3.0 General Amendments

Proposed Design Changes - South elevation

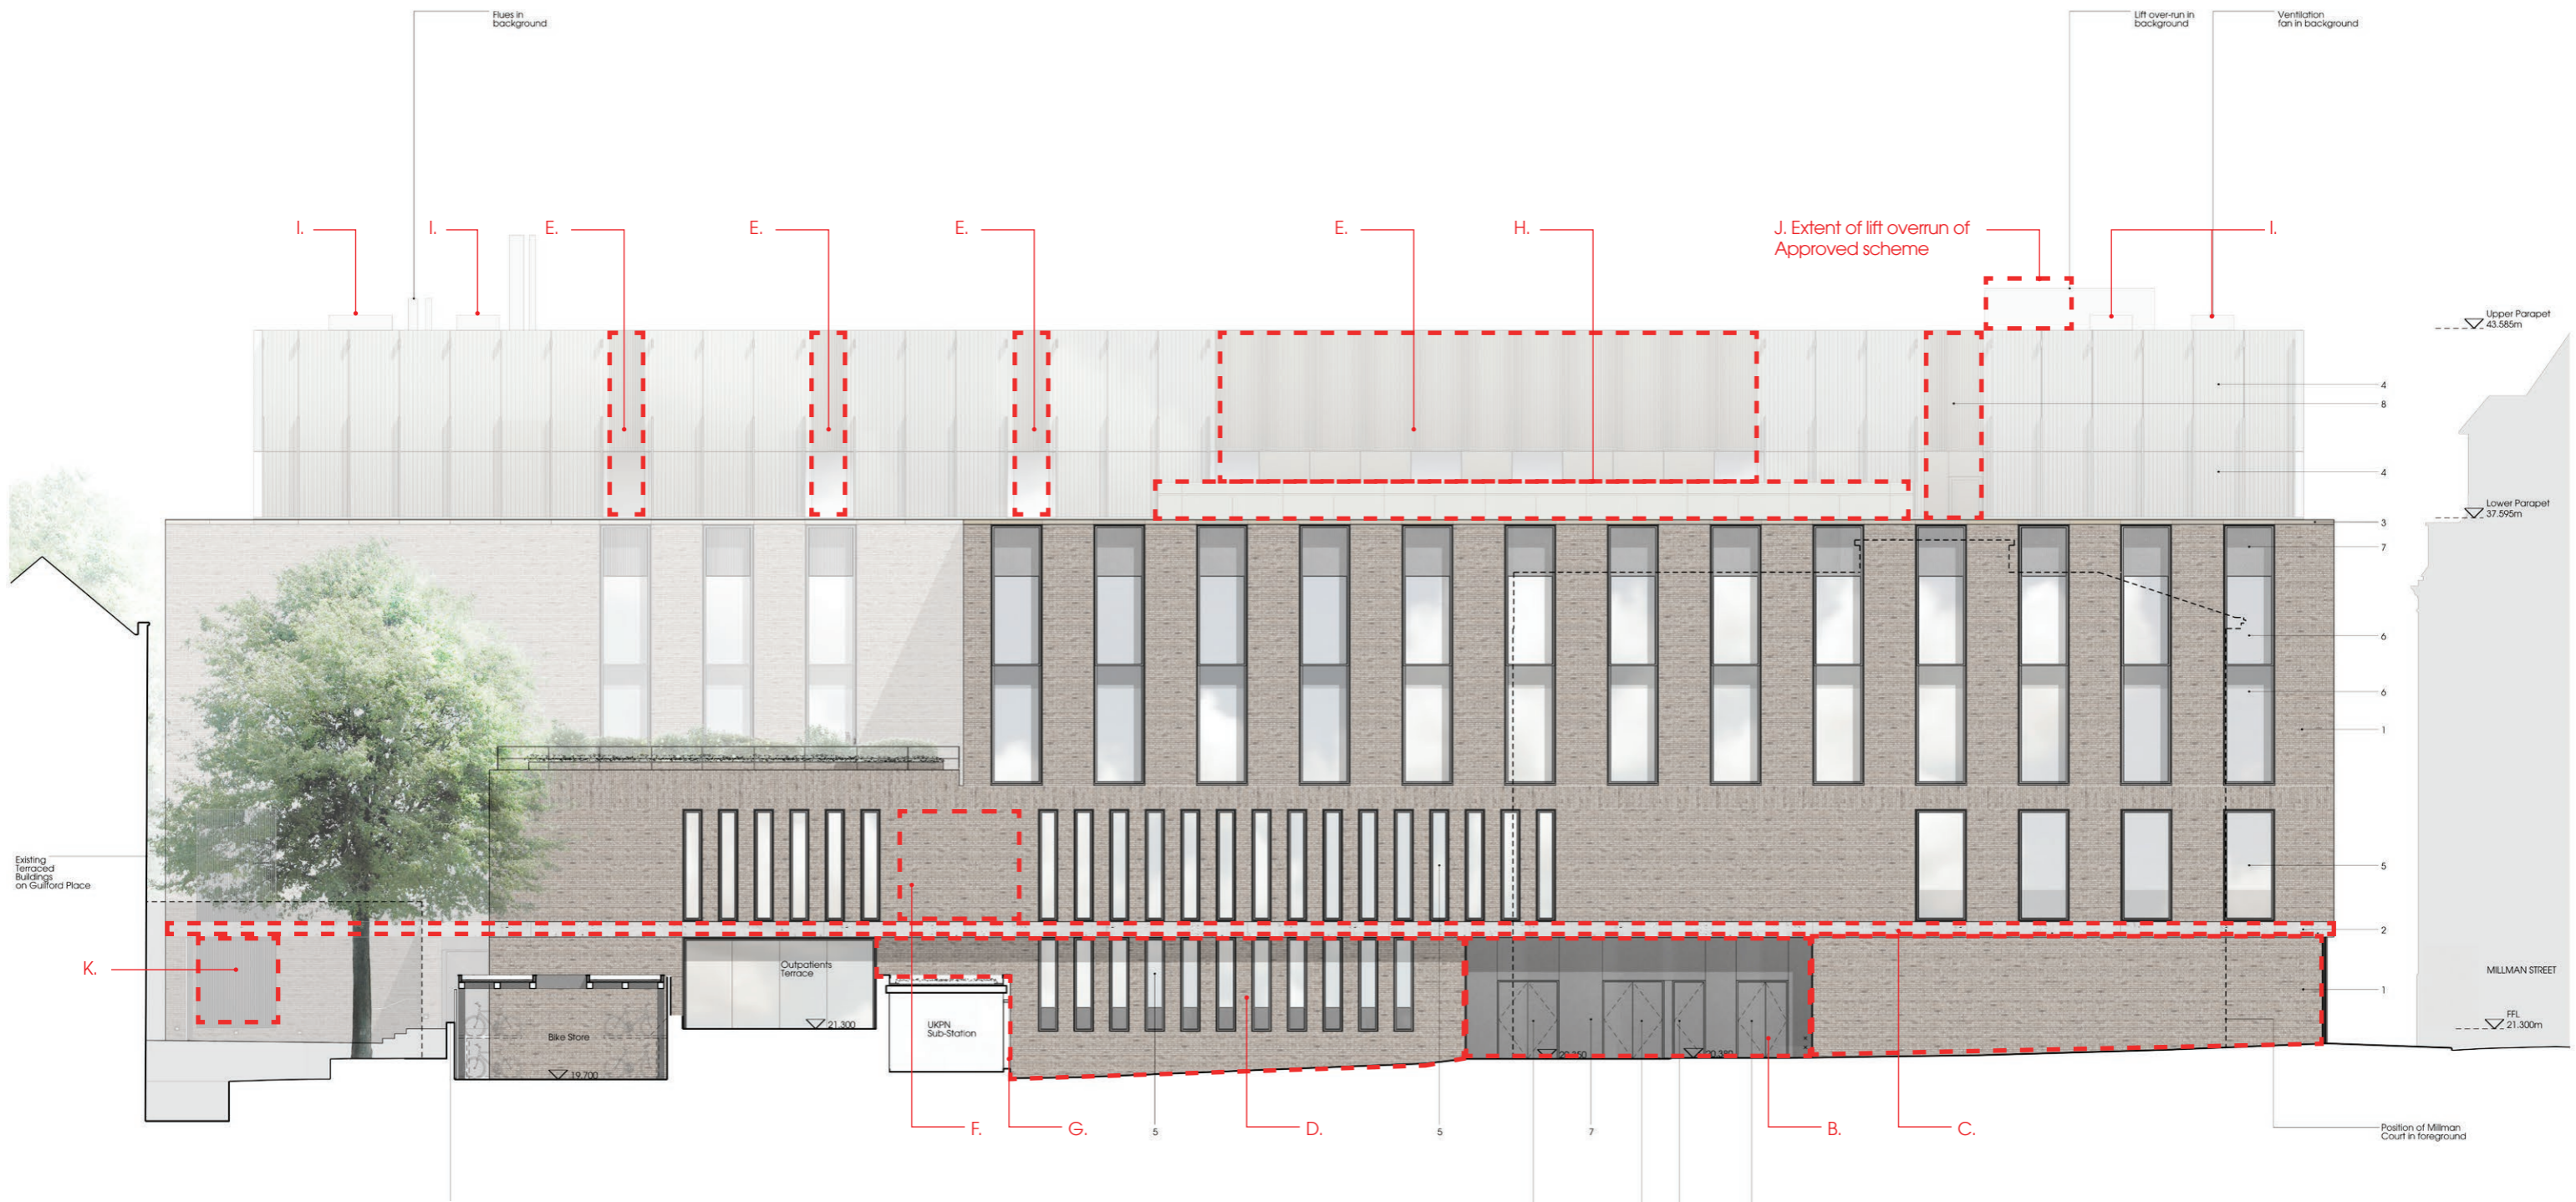
- B. Metal louvred doors and cladding to Core 2 escape doors and HV switchroom changed to flat metal cladding
- C. GRC in lieu of precast cladding to first floor fascia
- D. Stretcher bond in lieu of English bond brickwork on ground floor
- E. GMP: extent of louvres on level 5 revised to suit MEP design for plant areas.
- F. Five less slot windows on ground and first floor on the south elevation as a result of setting out building to brick dimensions and structural coordination
- G. Metal cladding to stand-alone substation omitted. Substation to be painted in colour to match other metalwork on ground floor.
- H. Main atrium rooflight raised to incorporate smoke extract louvres
- I. Ventilation fans added on roof level
- J. Lift overrun dimensions changed
- K. Additional ventilation louvres

Proposed Design - South elevation

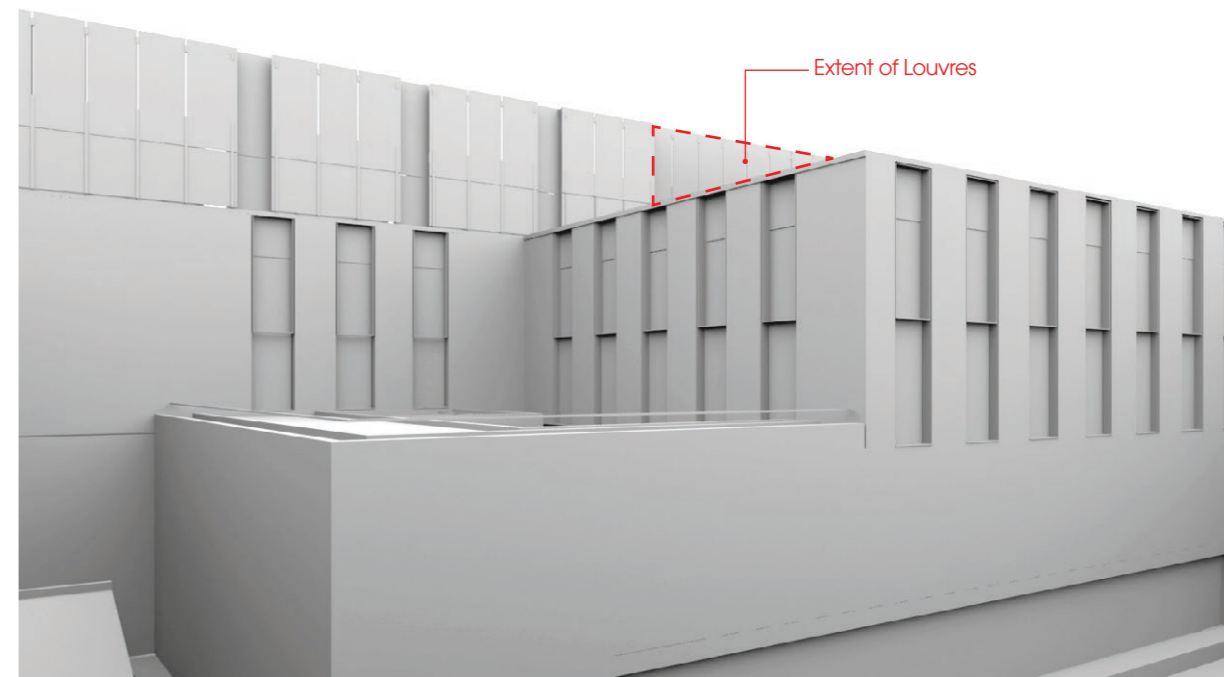
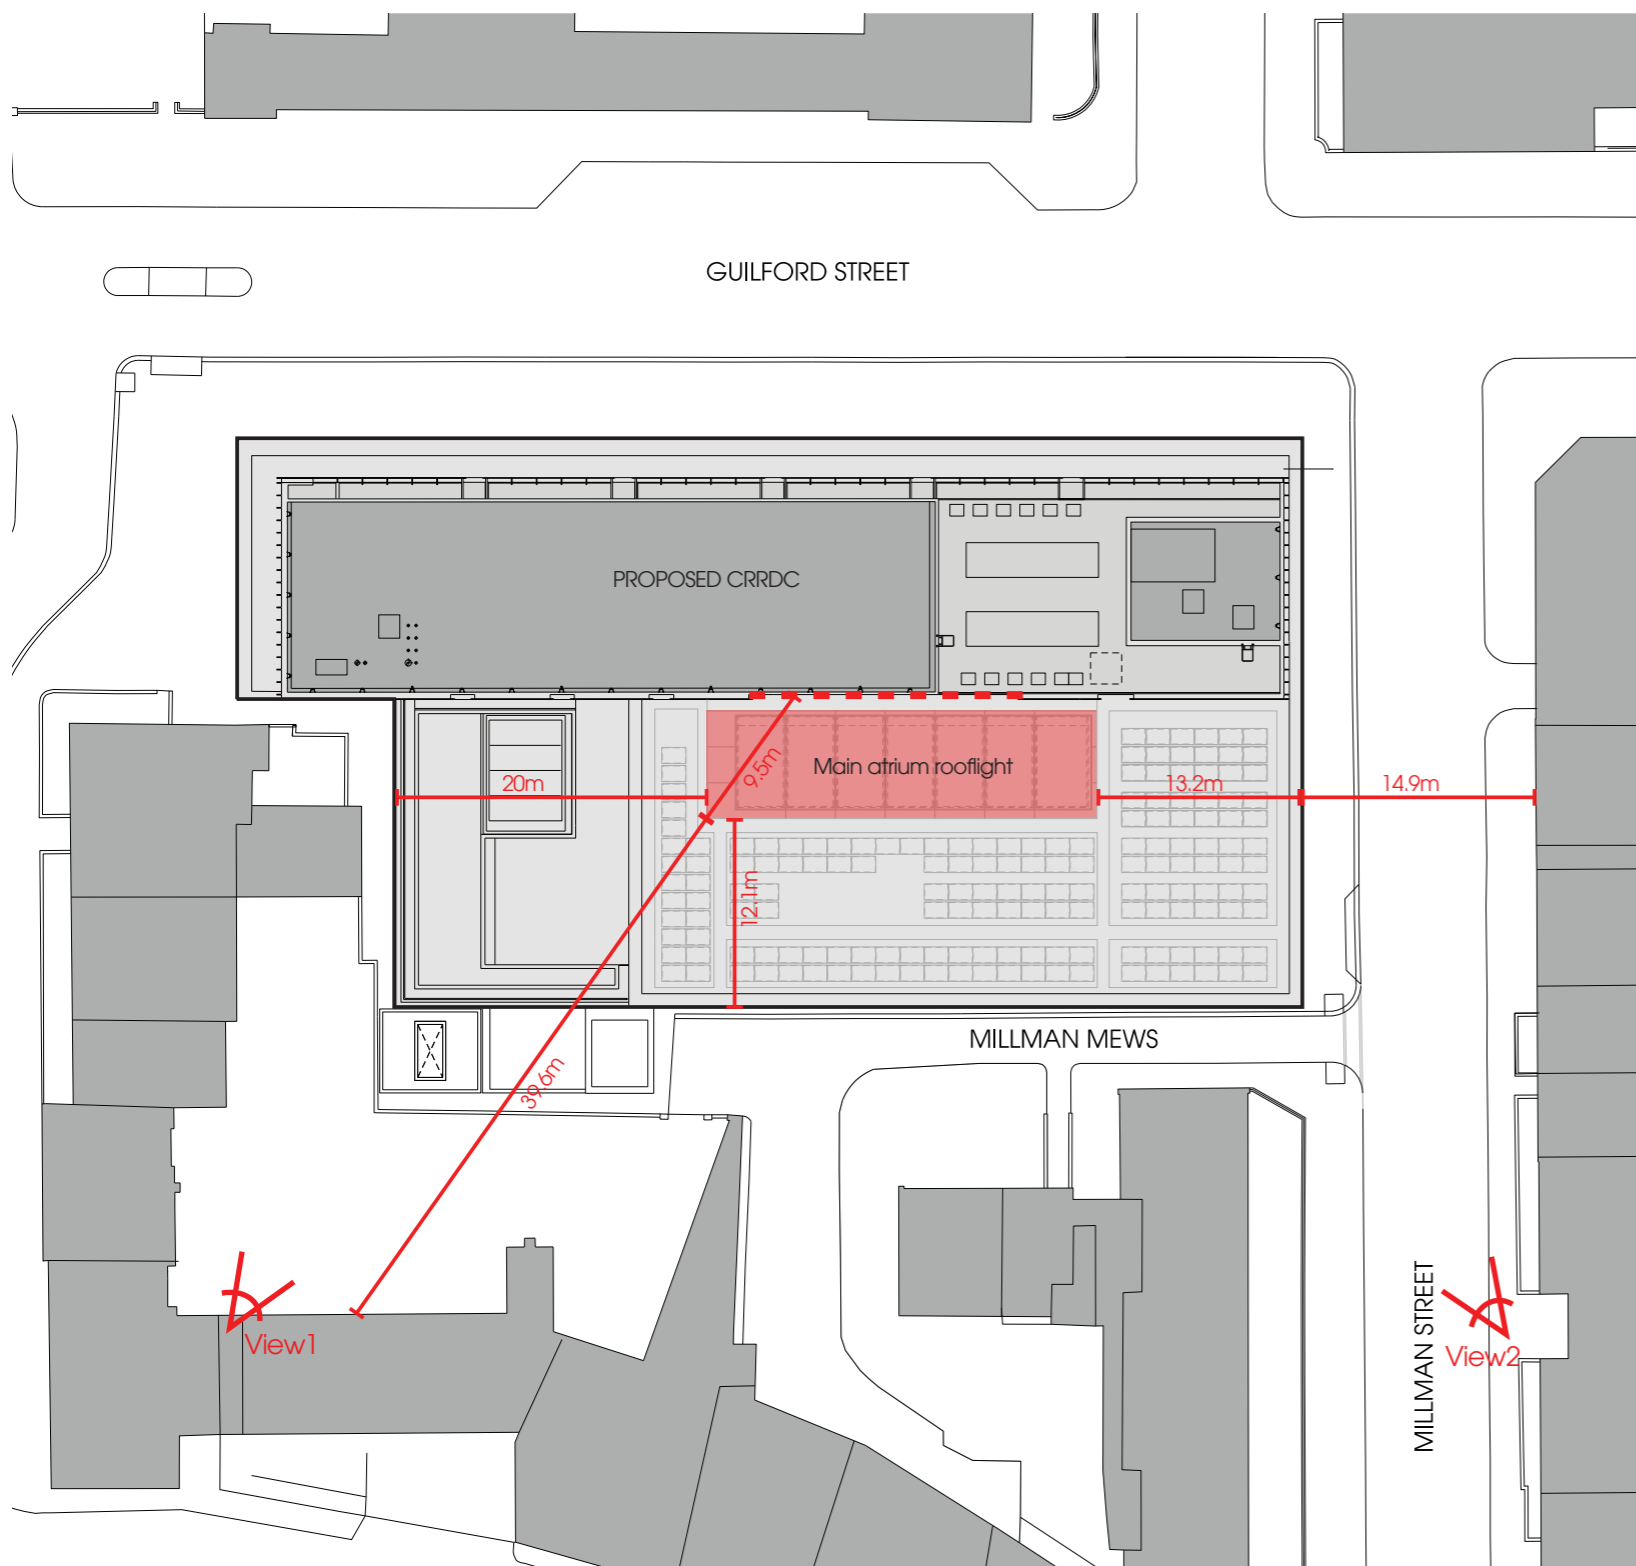
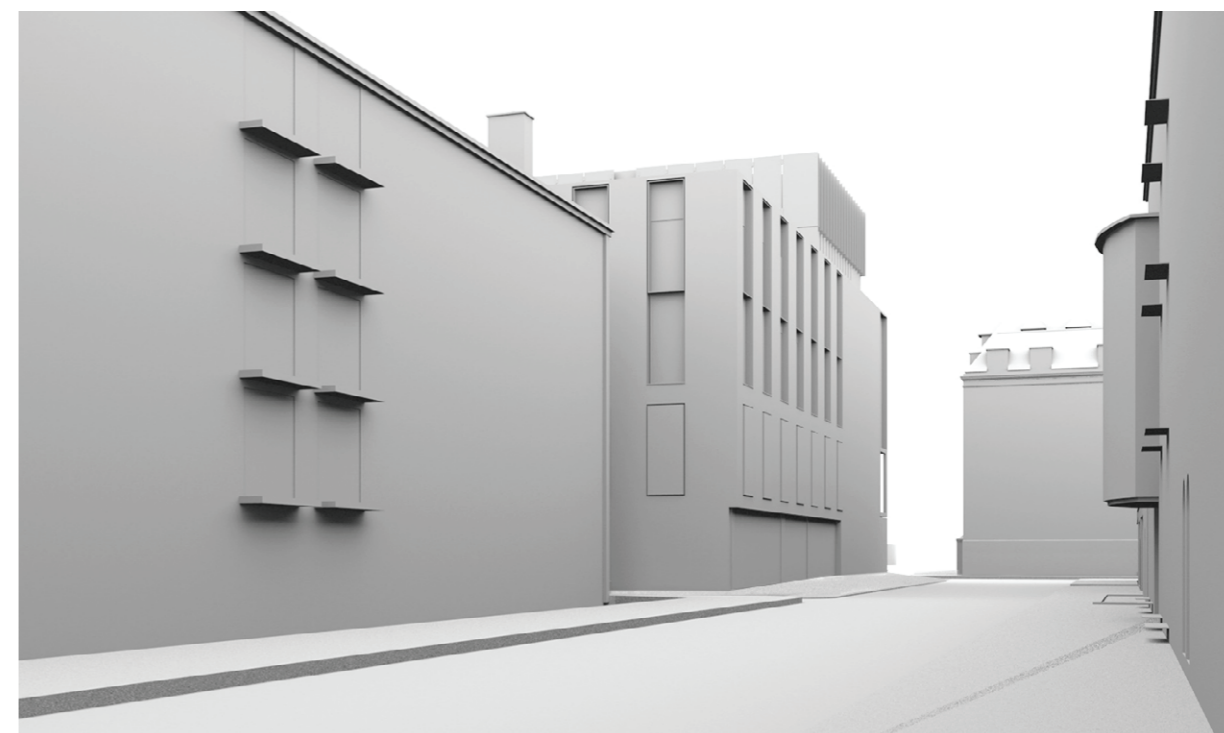
Main atrium rooflight and full extent of louvres on fifth floor will not be visible from neighbouring properties

Proposed Design Changes - West elevation

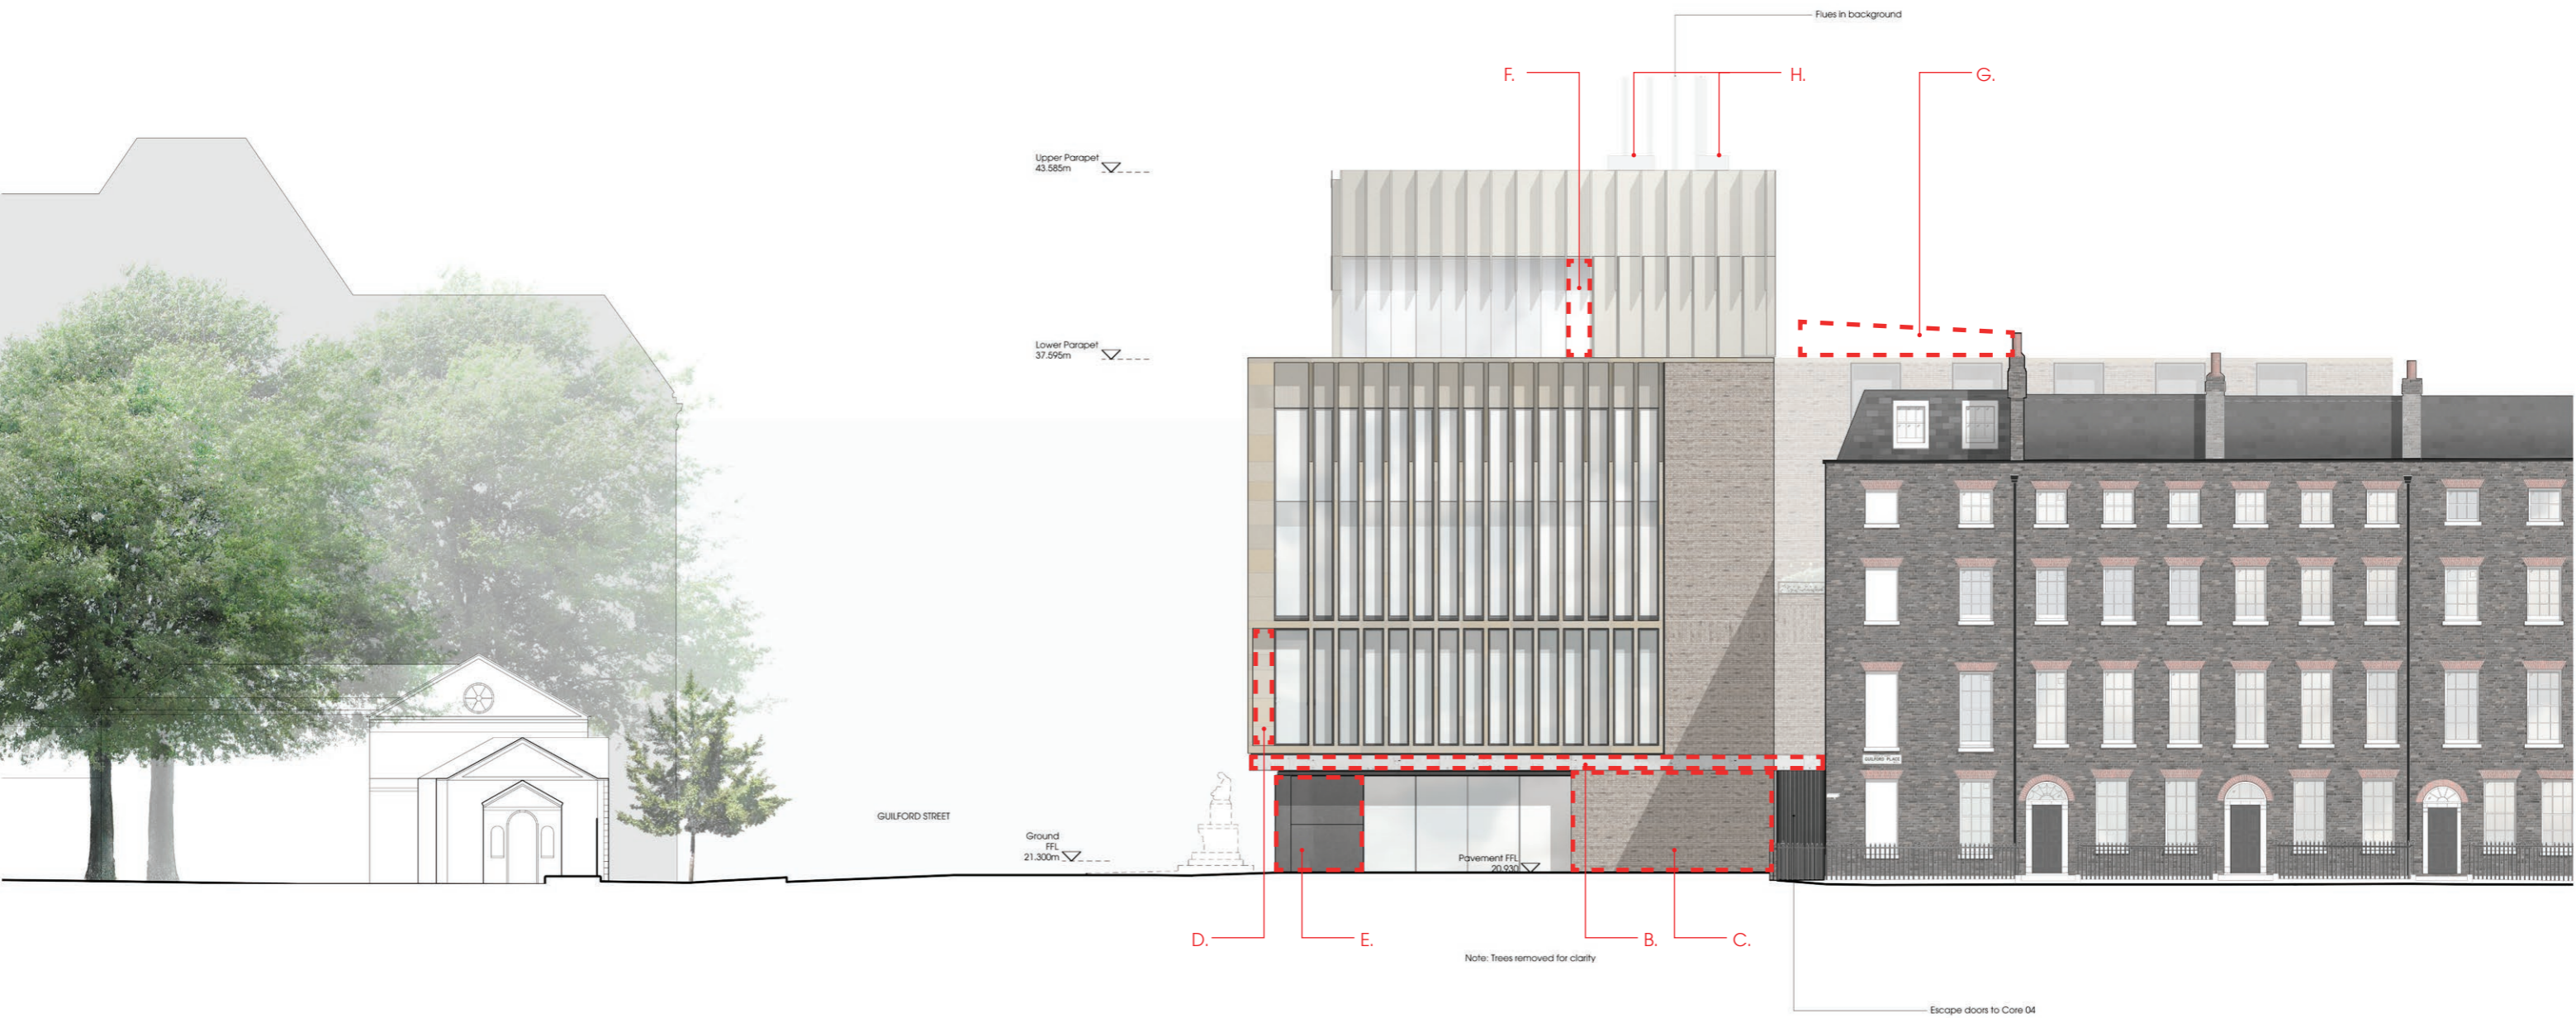
- B. GRC in lieu of precast cladding to first floor fascia
- C. Stretcher bond in lieu of English bond brickwork on ground floor
- D. Terracotta fin corner detail rationalised on first floor
- E. Extent of metal cladding on ground floor increased
- F. Glazing on fourth floor extended to suit internal layout
- G. Main atrium rooflight raised to incorporate smoke extract louvres
- H. Ventilation fans added on roof level
